RCE 尺寸變更 設變通知

RCE

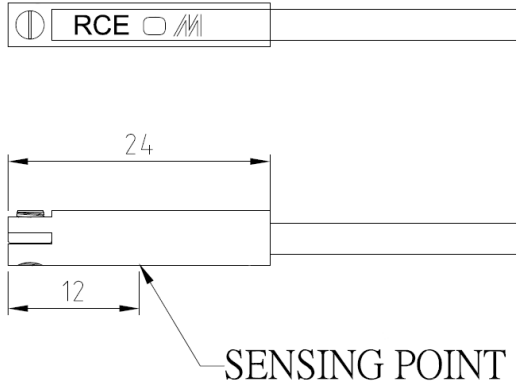
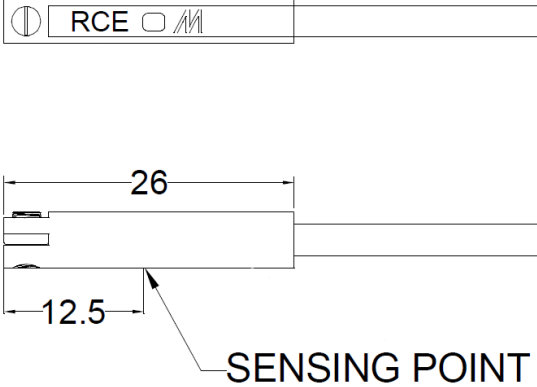
變更產品設計，修改外觀尺寸及感應位置。

設變前	設變後
 <p>Technical drawing of the RCE sensor before change. The drawing shows a rectangular component with a sensing point. The total length is 24, and the distance from the left edge to the sensing point is 12.</p>	 <p>Technical drawing of the RCE sensor after change. The drawing shows a rectangular component with a sensing point. The total length is 26, and the distance from the left edge to the sensing point is 12.5.</p>

不影響產品性能及客戶使用，採自然汰換。
